Application of Chad Jacobs to rezone property from O-I (Office-Institutional) zoning district to MR-1 (Medium Density Residential-1) zoning district to allow for a single-family attached (townhome) development, at 729 Old Briarcliff Road.

PETITION NO: N7-2026-1106 Z-26-1248177

LOCATION: 729 Old Briarcliff Road, Atlanta, GA 30306

STAFF ANALYSIS

DESIGNED: DATE: MAY 08, 2024
CHECKED: MHK
JOB NO.: 2017-010
SCALE: AS SHOWN
DRAWING NUMBER
C1.0
SHEET NUMBER 1

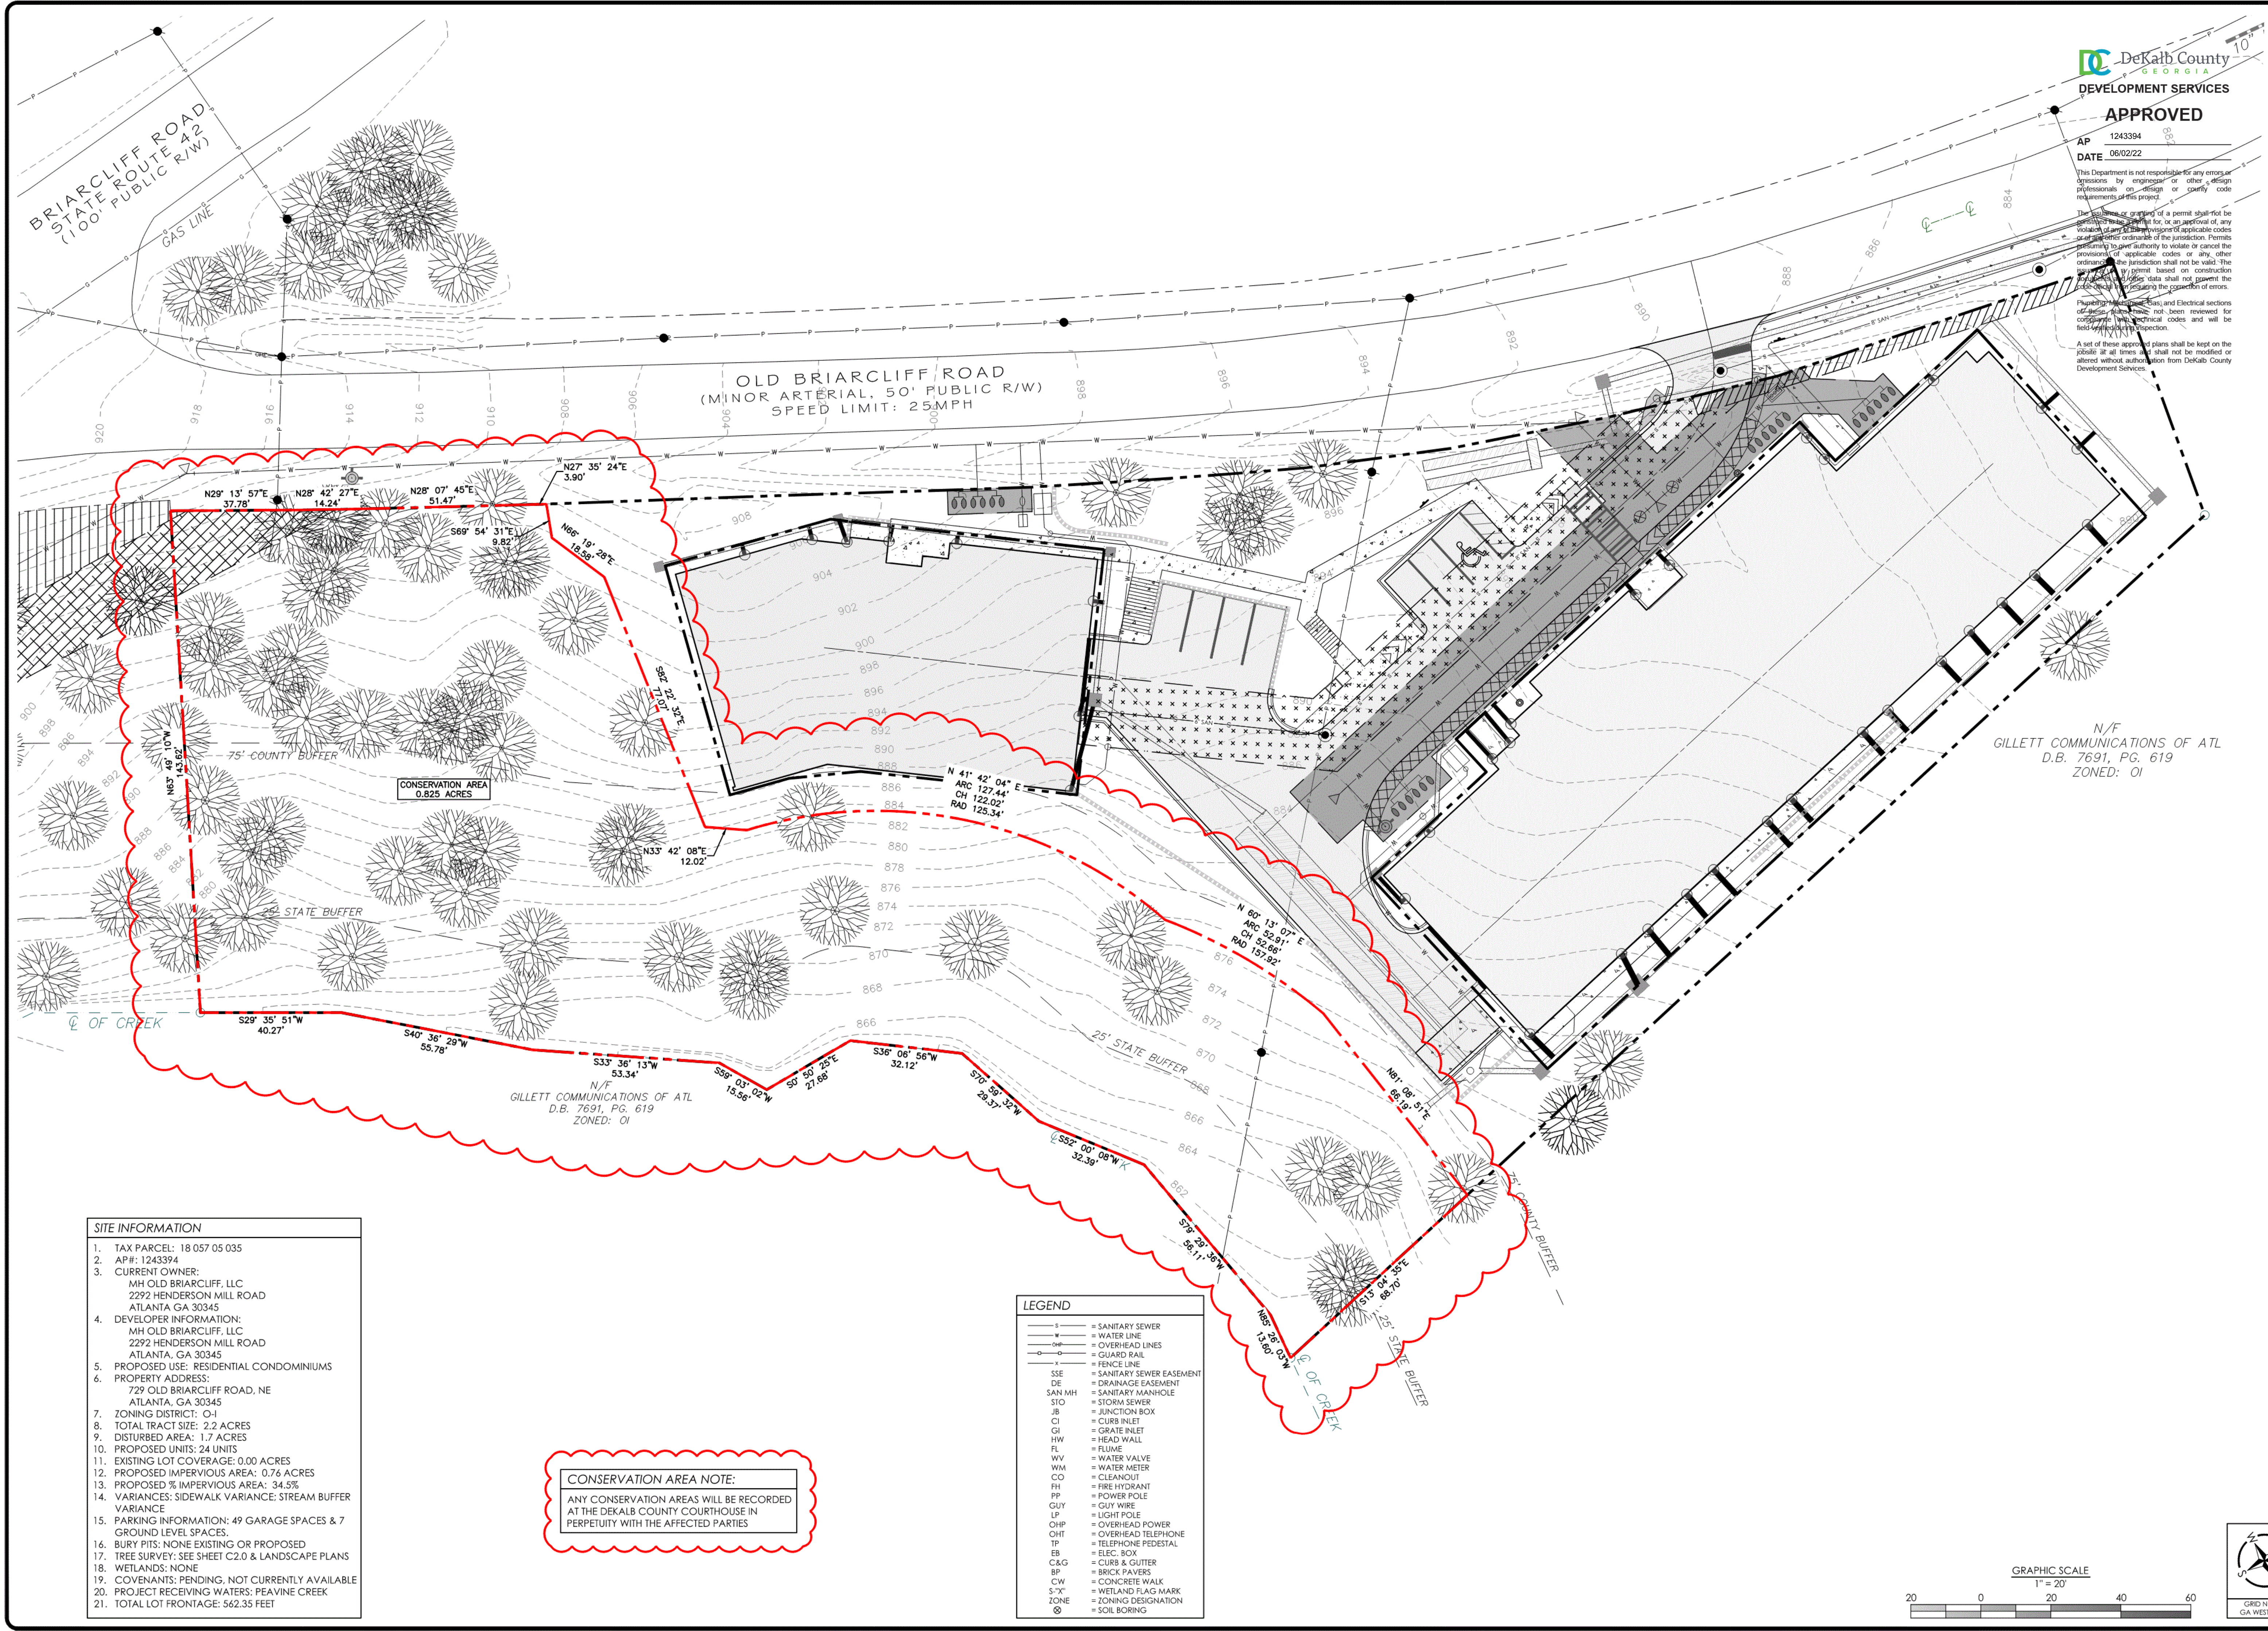
1. The subject property shall be developed with up to 14 single-family attached (either fee-simple or condominium) dwelling units in general conformance with the site plan titled “The Flats at Old Briarcliff” and dated May 08, 2024. The site plan is conceptual, however - to allow for flexibility in design after taking existing conditions in account - subject to approval by the Director of Planning and Sustainability or their designee.

3. Dwelling units with frontage on Old Briarcliff Road shall be set back at a distance no greater than 20 feet from the front property line along Old Briarcliff Road.

4. Units with frontages on Old Briarcliff Road shall provide pedestrian paths/walkways that extend from each units’ entrances to the sidewalk to be provided on Old Briarcliff Road.

Land Development has provided comments that raise potential doubts as to whether or not the site may be able to fit required stormwater management systems without some degree of disturbance, and noted

that traditional detention/retention ponds are not possible. Compliance with the *Land Development Code* would be determined at the Sketch Plat and/or LDP phase of permitting, however.

1. The subject property shall be developed with up to 14 single-family attached (either fee-simple or condominium) dwelling units in general conformance with the site plan titled “The Flats at Old Briarcliff” and dated May 08, 2024. The site plan is conceptual, however - to allow for flexibility in design after taking existing conditions in account - subject to approval by the Director of Planning and Sustainability or their designee.
